UNITED STATES
NUCLEAR REGULATORY COMMISSION
REGION I
475 ALLENDALE ROAD
KING OF PRUSSIA, PENNSYLVANIA 19406-1415

**SUBJECT: ENVIRONMENTAL ASSESSMENT AND FINDING OF NO SIGNIFICANT
IMPACT - HERITAGE MINERALS, INC. (HMI)**

**SUBJECT: CONFIRMATORY SURVEY PLAN FOR PORTIONS OF THE HERITAGE
MINERALS, INCORPORATED FACILITY IN LAKEHURST, NEW JERSEY
(DOCKET NO. 040-08980; RFTA NO. 01-012)**

**CONFIRMATORY SURVEY PLAN
FOR PORTIONS OF THE
HERITAGE MINERALS INCORPORATED FACILITY
LAKEHURST, NEW JERSEY
(DOCKET NO. 040-08980; RFTA NO: 01-012)**

FIGURE 24: Former Monazite Pile - Measurement and Sampling Locations

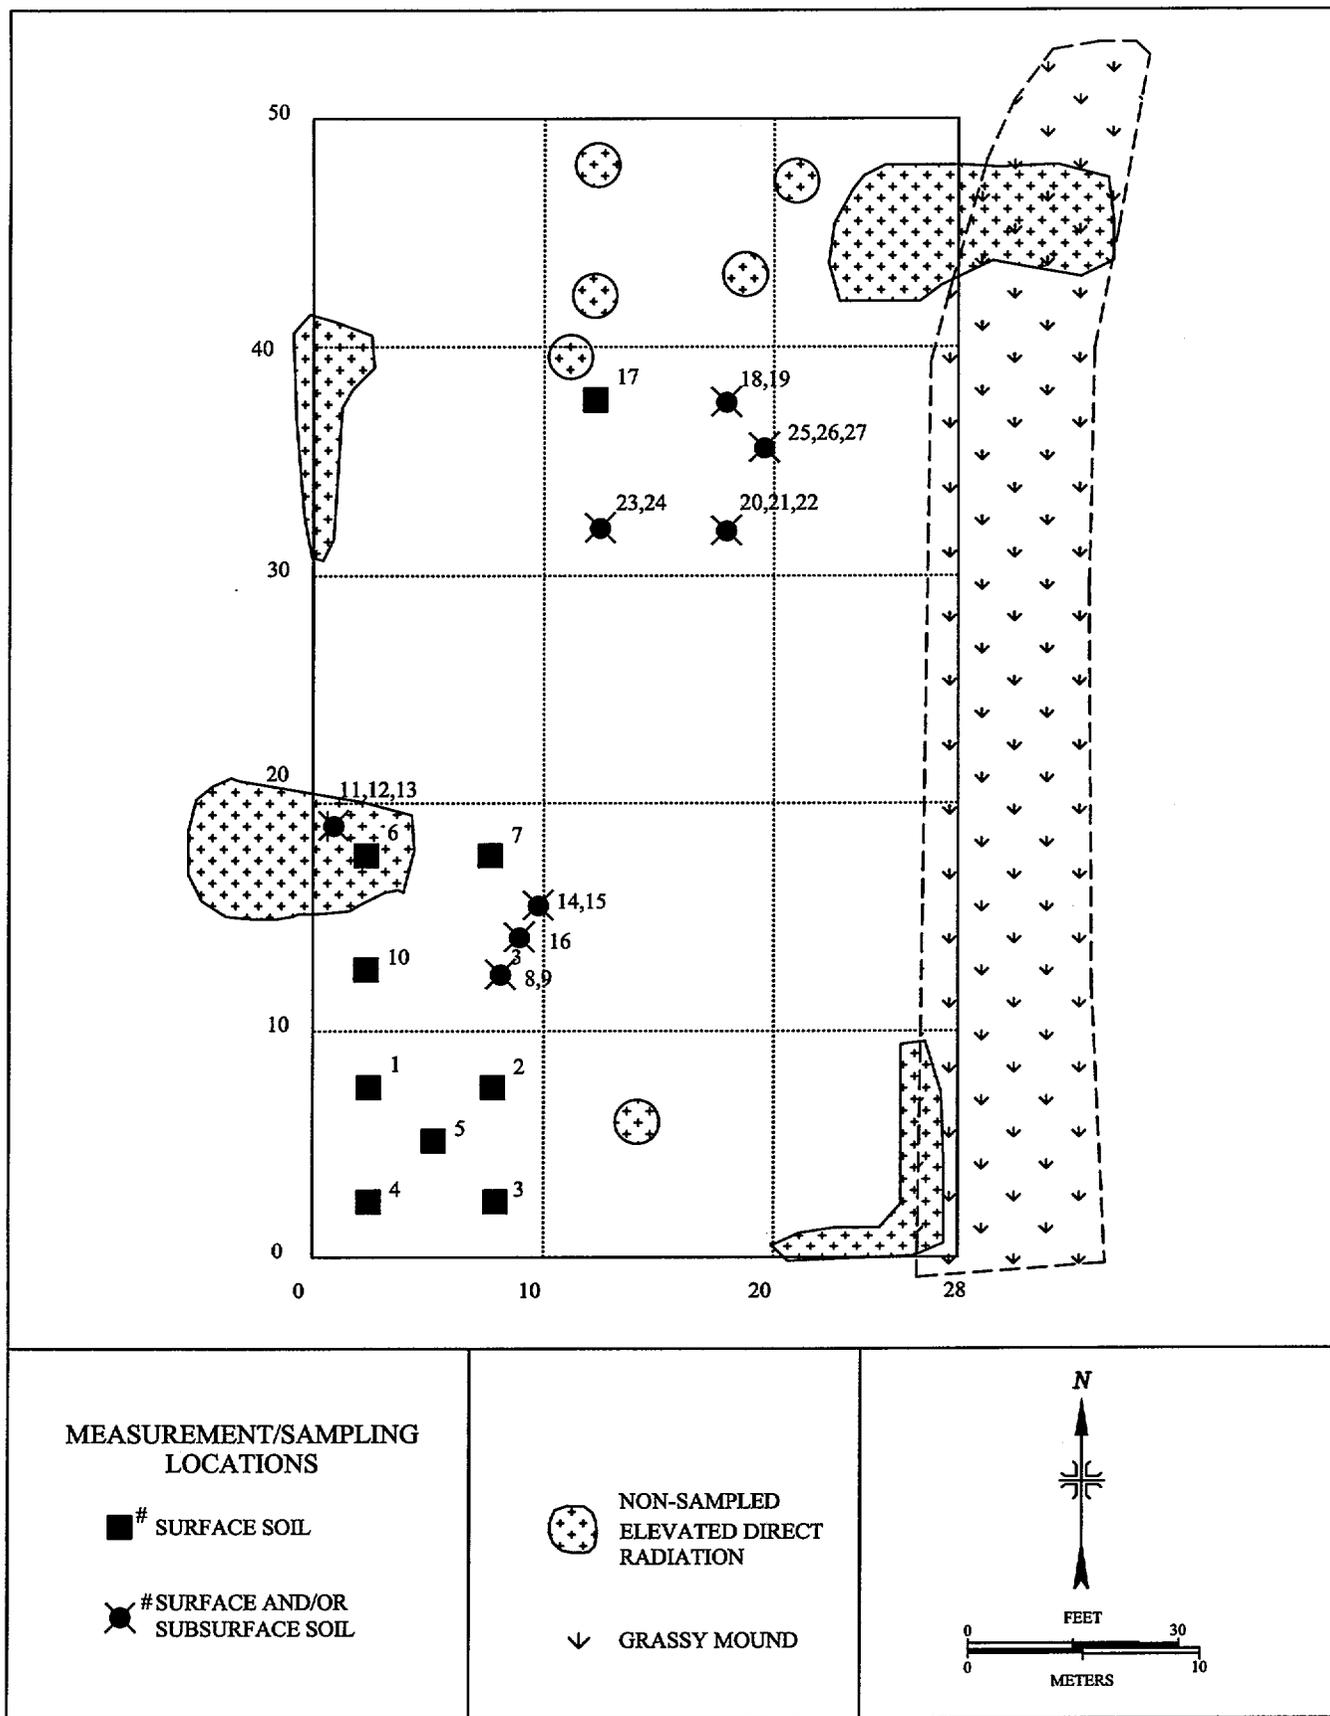
In contrast to your surveys results, NRC surveys show that surface activity levels and radionuclide concentrations in the soil where the pile was removed and in adjacent areas to the pile were not remediated to meet unrestricted release guidelines. Preliminary results from the ORISE survey were discussed with you during the management meeting held on January 22, 2002, at the NRC Region I office. Enclosed is the preliminary survey results taken from the February 2002 draft ORISE report. The entire contents of the final report will be sent to you under separate cover.

We acknowledge your efforts to initiate site decommissioning and remove the monazite pile. However, additional strategies are warranted to complete necessary remediations. For contaminated soil, surveys and sampling should be performed in accordance with NUREG/CR-5849 to meet commitments in the FSSP. In addition, provide your strategy for verifying that all licensed material previously part of the pile has been successfully removed from the site. For
